## Access Compliance Report Public Rights-of-Way (Curb Ramps)

Intersection ID: 27854
 Main Street: PARADISE\_RIDGE\_RD
 Cross Street: VENTANA\_CT
 Location:
 NE

ADA ID: 30DFA77F2AEC
 Ramp Type: Perp
 Initial Pass/Fail: Fail
 Overall Compliance: No
 Severity Score: 25

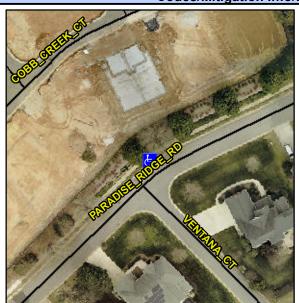
Not Found, R304.2.2

Field Measurements/Component Compilance					
Compliance Description		Data	Compliance Description		Data
N/A	Ramp Length (in)	47.0	No	Ramp Slope (%)	14.9
Yes	Ramp Width (in)	48.0	Yes	Ramp XSlope (%)	1.6
N/A	Flare Type LT	N/A	N/A	Flare Type RT	N/A
N/A	Flare Slope LT (%)	N/A	N/A	Flare Slope RT (%)	N/A
N/A	Flare Traversable LT?	N/A	N/A	Flare Traversable RT?	N/A
N/A	Landing Length (in)	N/A	N/A	DWS Provided?	N/A
N/A	Landing Width (in)	N/A	N/A	DWS Contrast?	N/A
N/A	Landing Slope (%)	N/A	N/A	DWS Length (in)	N/A
N/A	Landing X Slope (%)	N/A	N/A	DWS Full Width?	N/A
N/A	Landing Curb? (Y/N)	N/A	N/A	DWS Offset (in)	N/A
N/A	Shared Landing?	N/A			
N/A	Gutter Ponding?	N/A	N/A	Gutter Slope (%)	N/A
N/A	Gutter Lip Ht (in)	N/A	N/A	Gutter X Slope (%)	N/A
N/A	Painted X Walk1?	No	N/A	Painted X Walk2?	N/A
	X Walk 1 Direction	To SE		X Walk 2 Direction	N/A
N/A	X Walk 1 Width (in)	N/A	N/A	X Walk 2 Width (in)	N/A
	X Walk 1 Slope (%)	2.2		X Walk 2 Slope (%)	N/A

Remove & Replace Entire Ramp.
